**FINAL DRAINAGE REPORT
FOR
FOREST LAKES FILING 7
EL PASO COUNTY, COLORADO**

December 2021

Job no. 1175.70
PCD File # SF-21-XXX

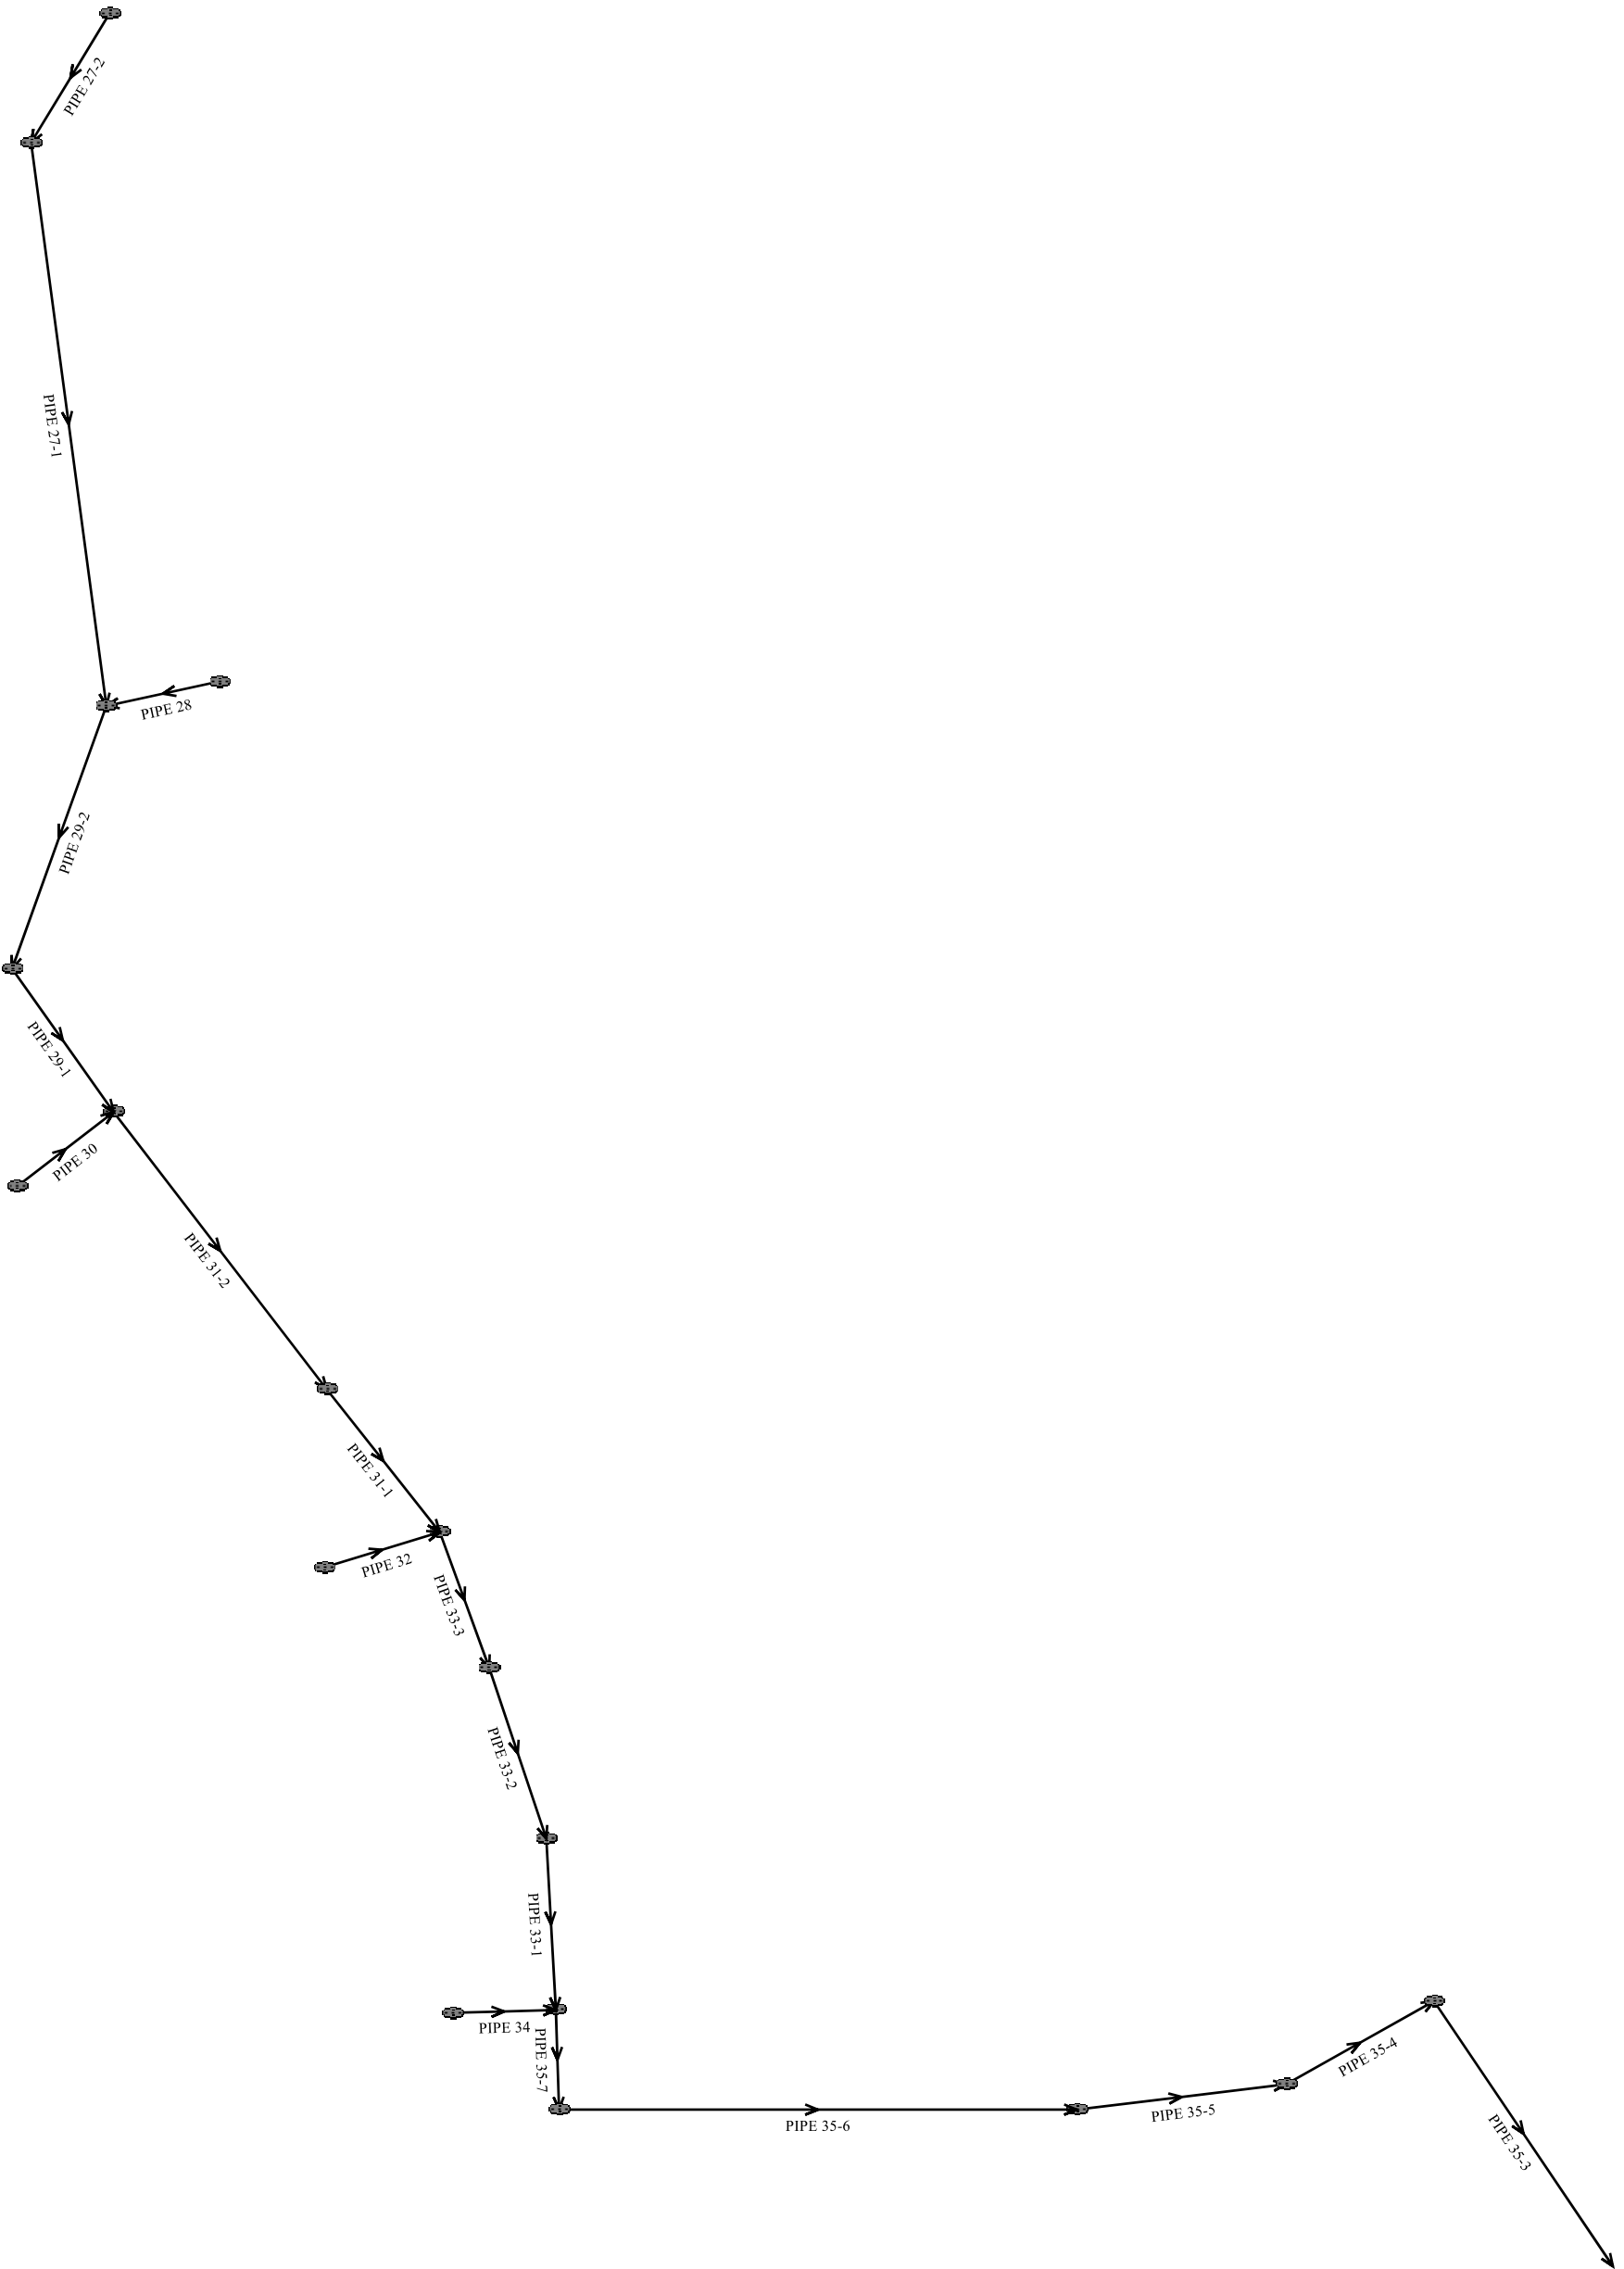
Please provide deviation request for velocities greater than 18 fps

FOREST LAKES FILING 7			
FINAL DRAINAGE REPORT TRIBUTARY AREA TO PROPOSED POND A			
DESIGNED BY	MAL	SCALE	DATE 11/18/18
DRAWN BY	MAL	(H) 1" = 100'	SHEET 2 OF 2
CHECKED BY	(V)	1" = N/A	JOB NO. 1175.70

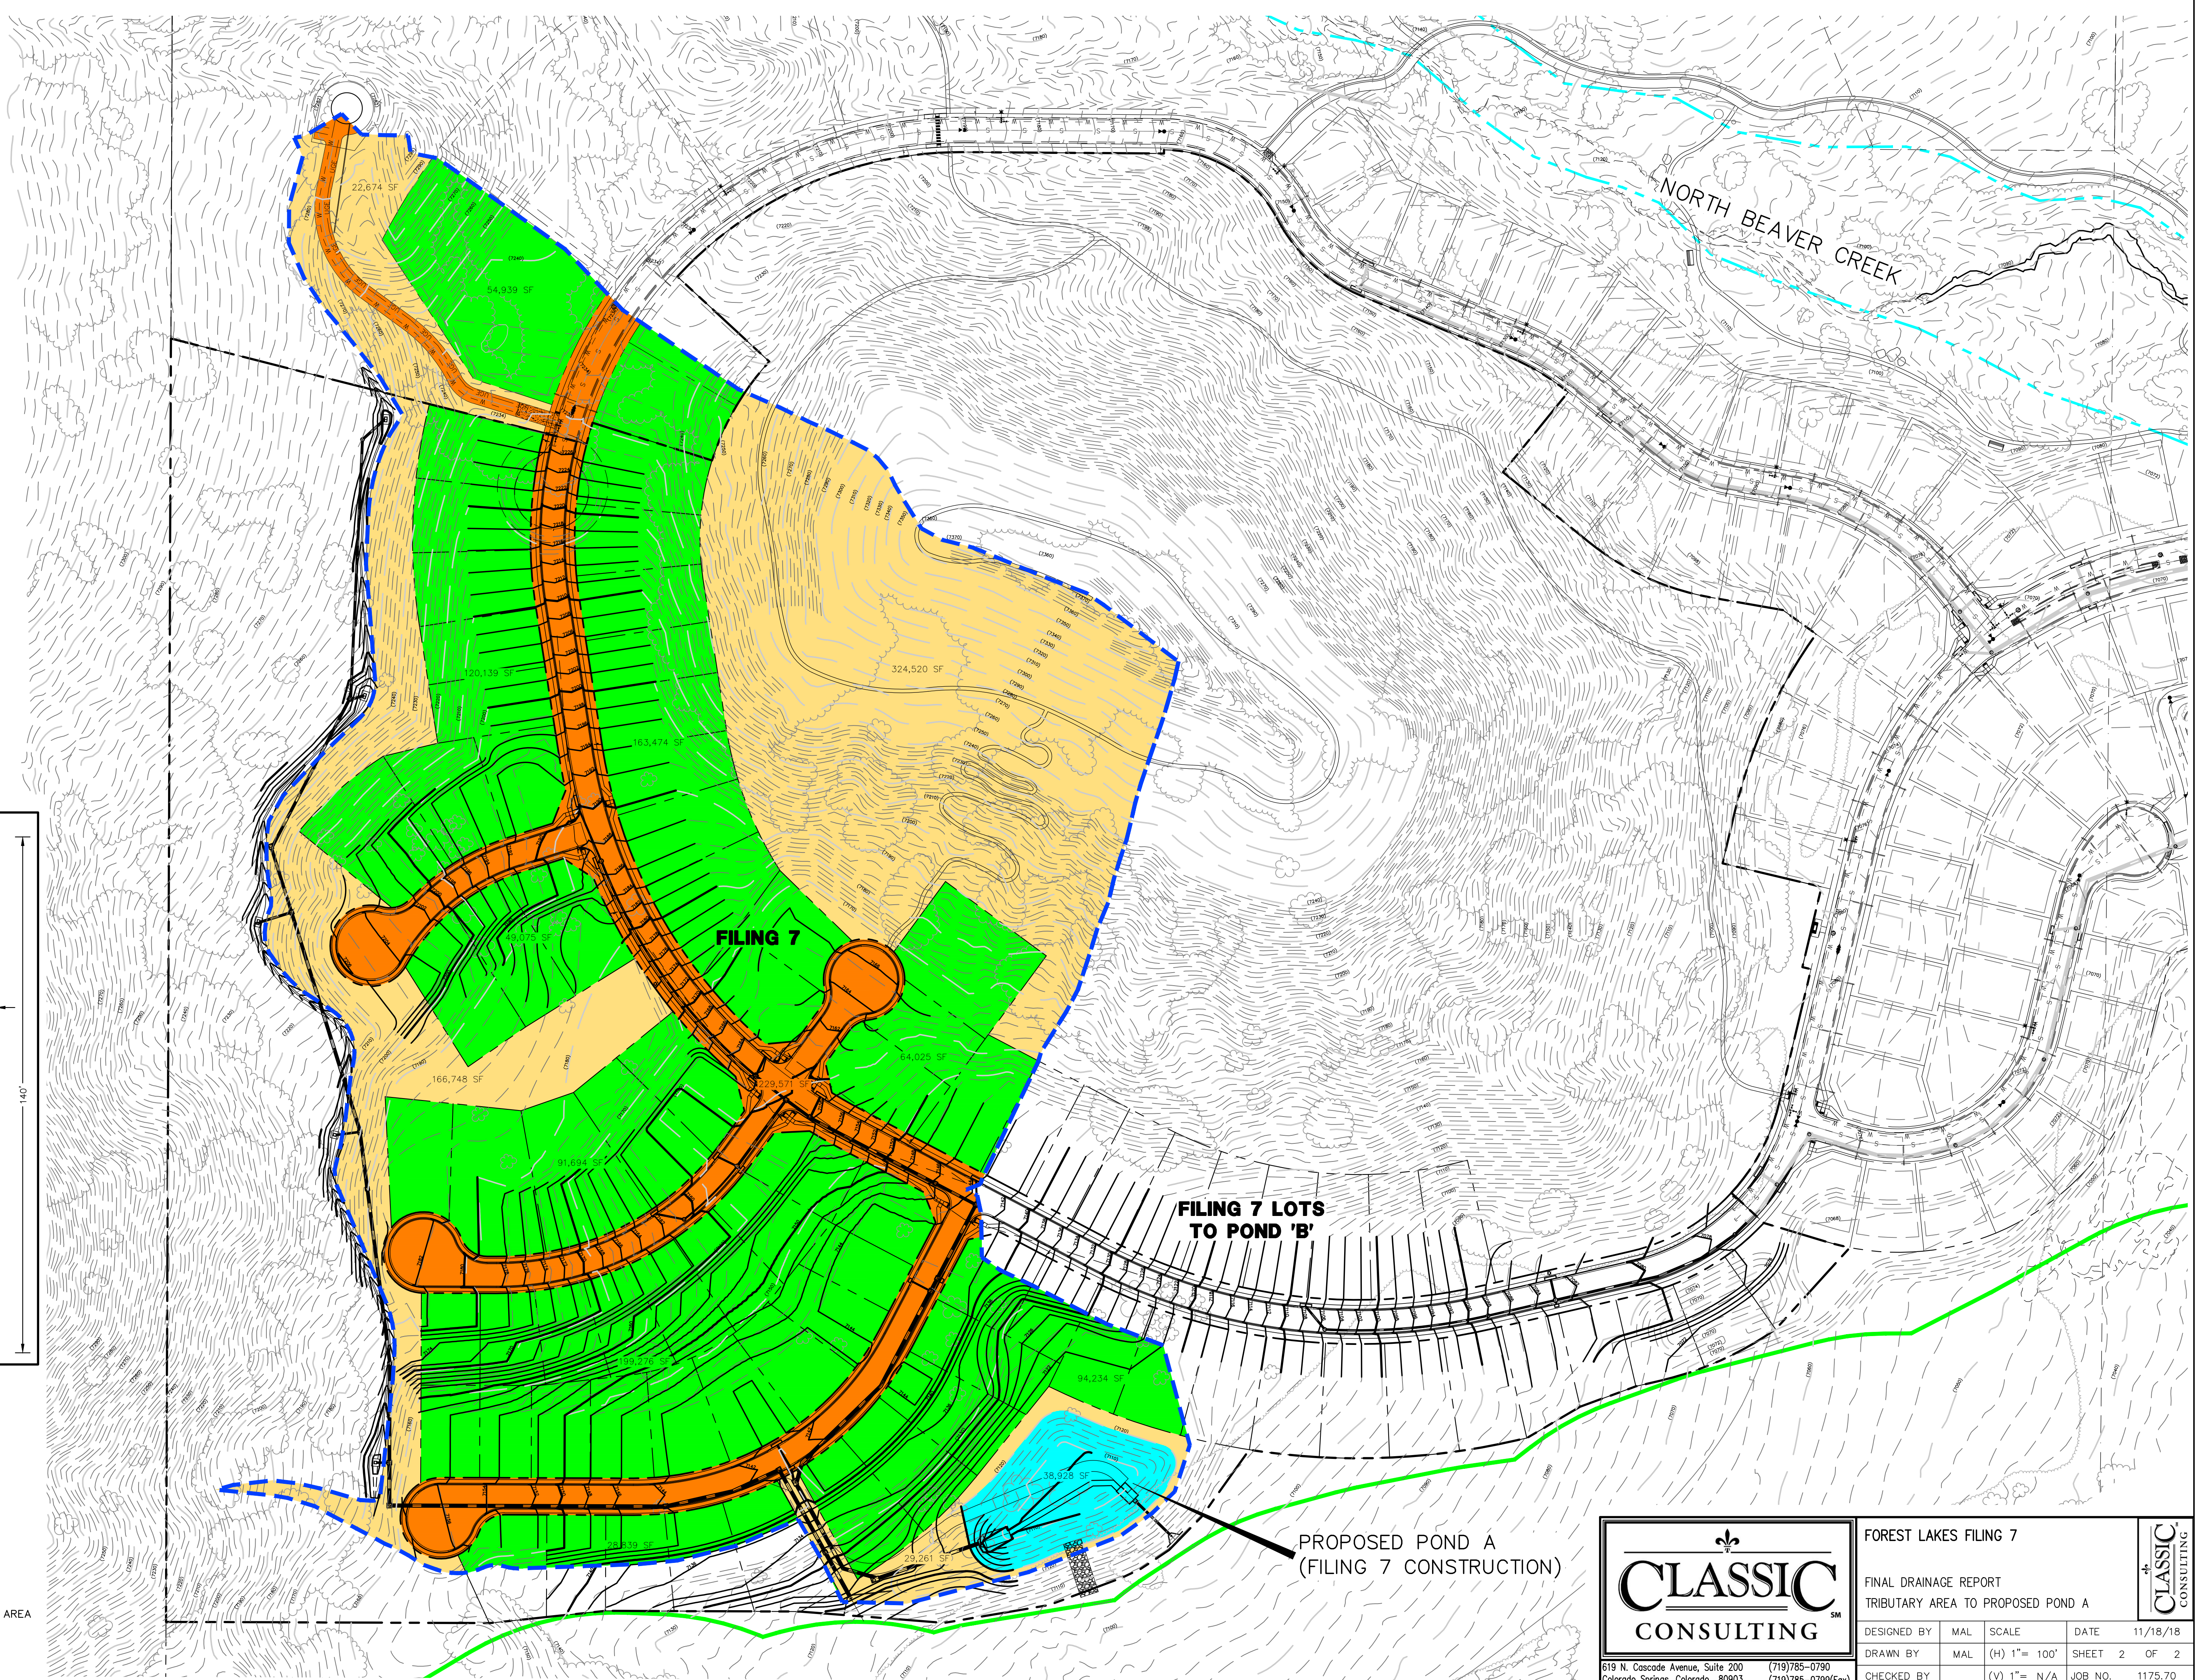
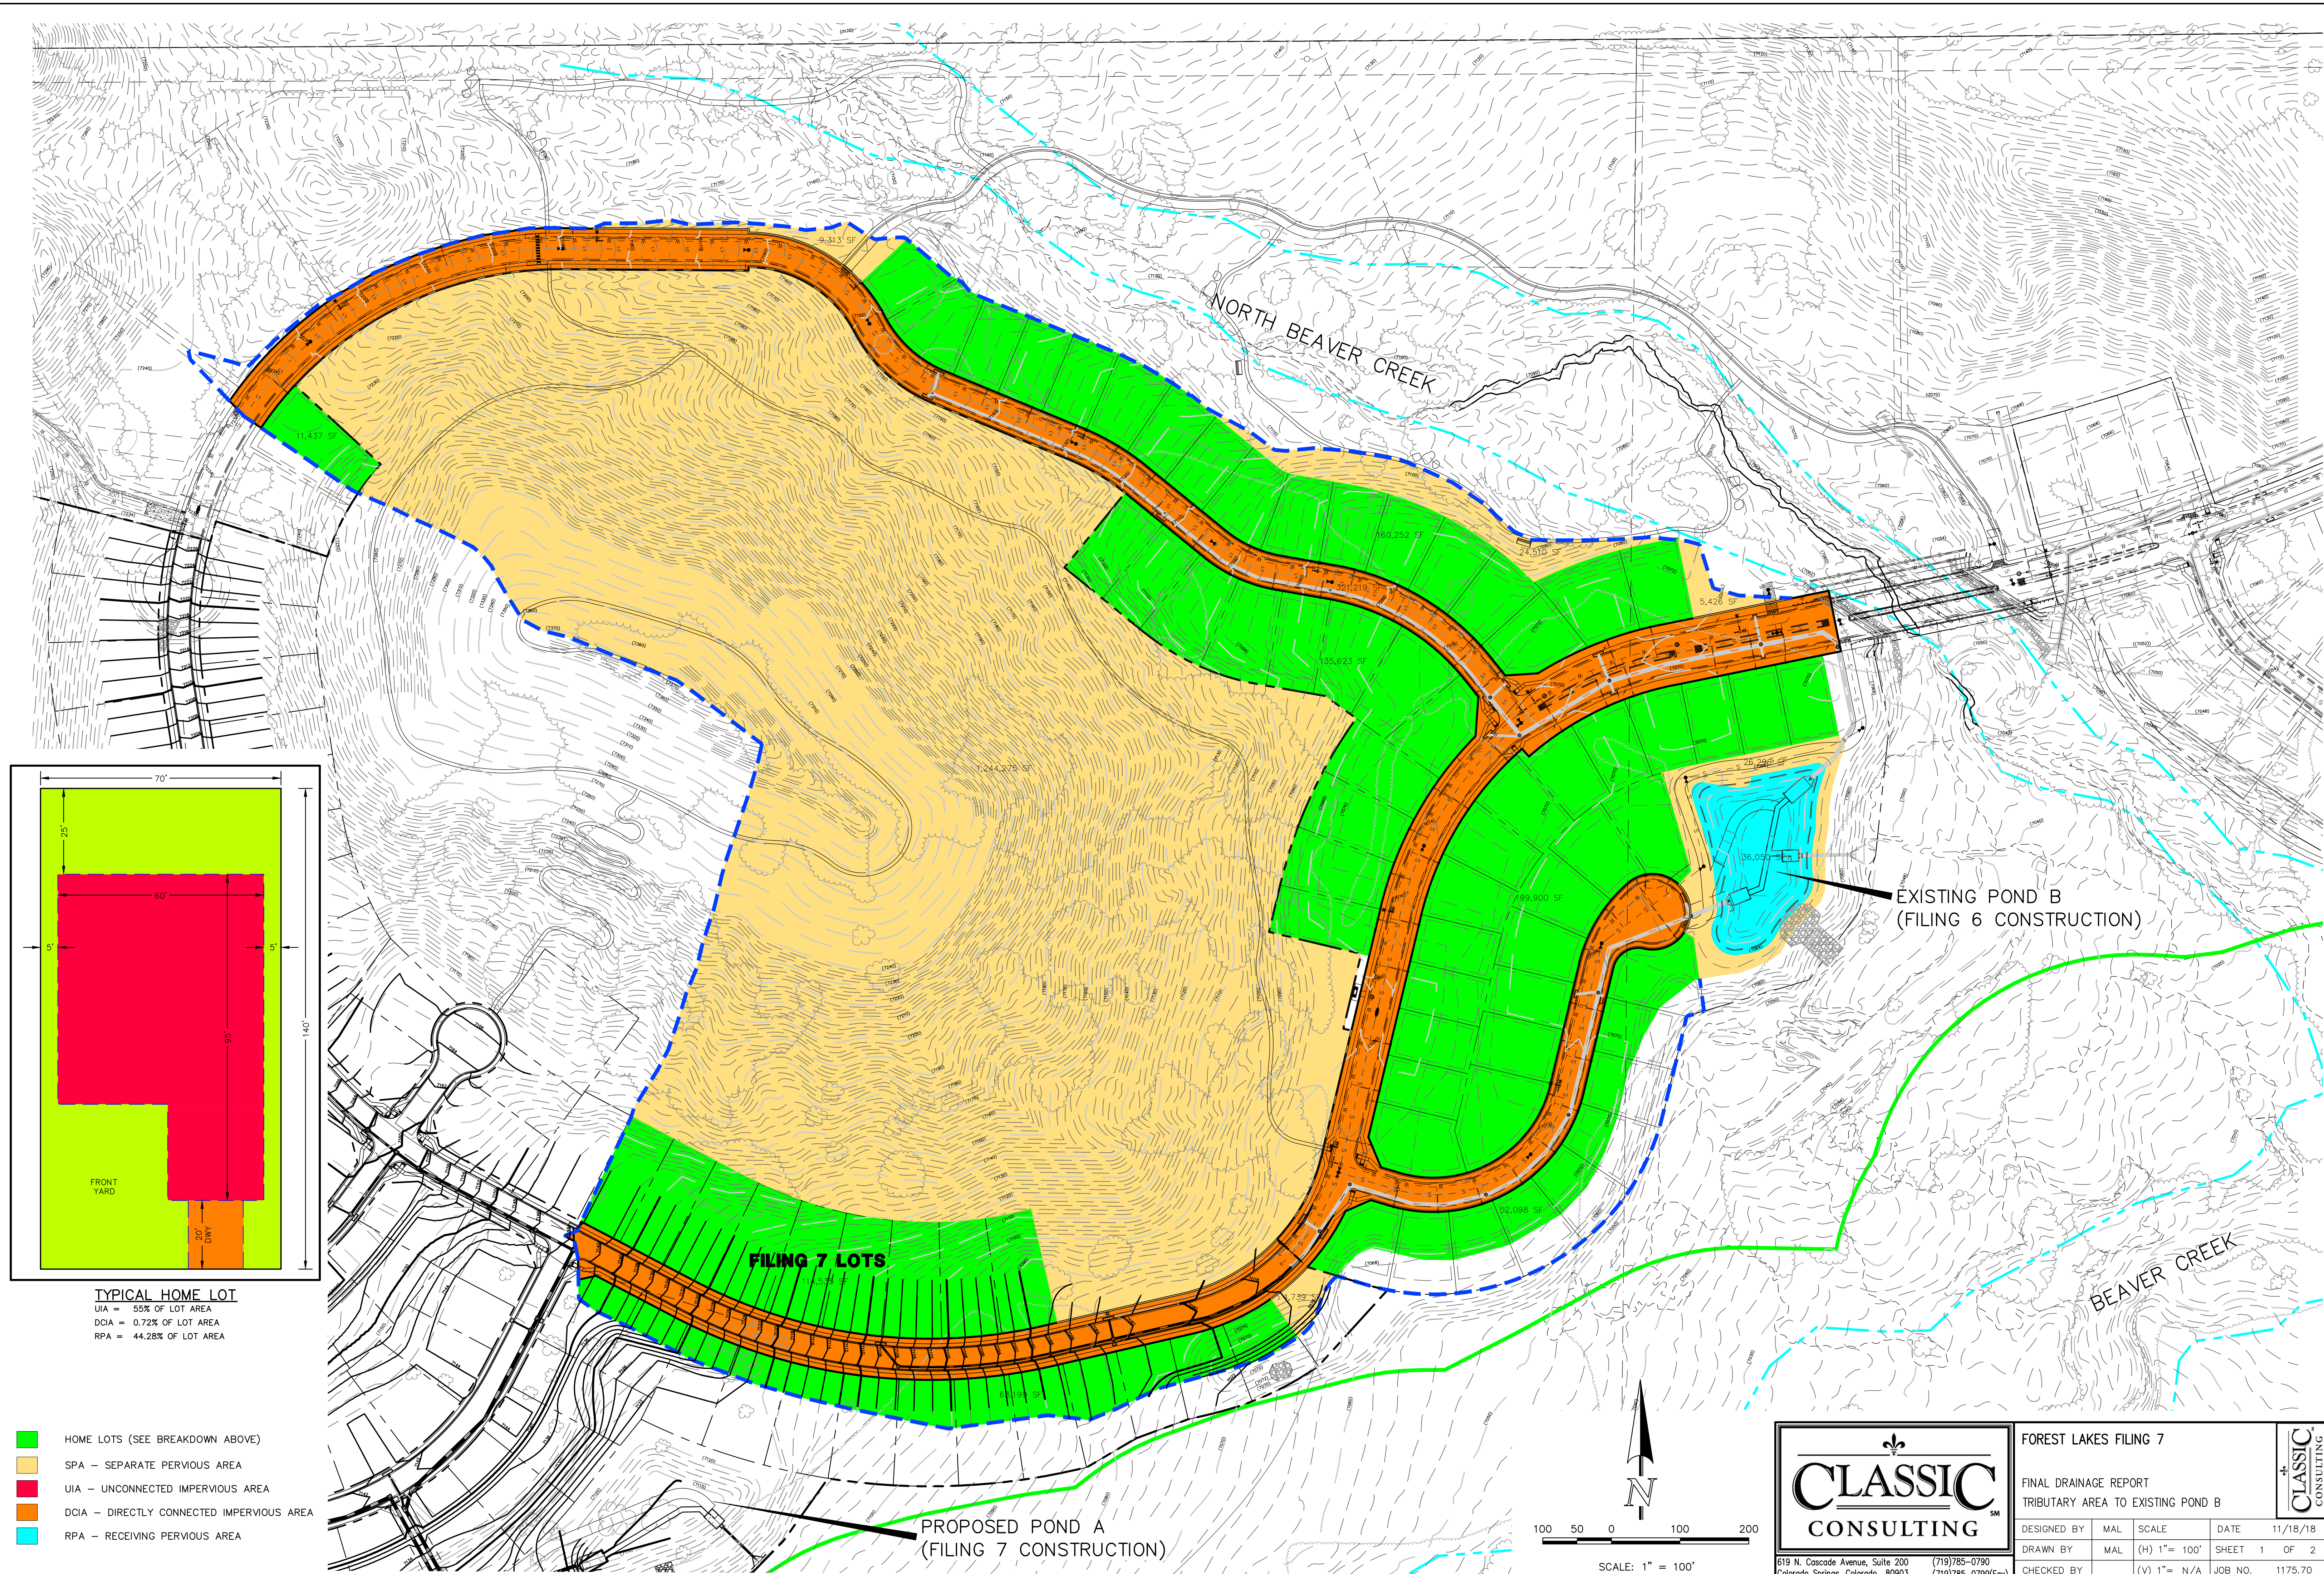
Unless you plan on using runoff reduction, break down the site into areas that will be
 1. untreated
 2. treated by Pond A
 3. treated by Pond B
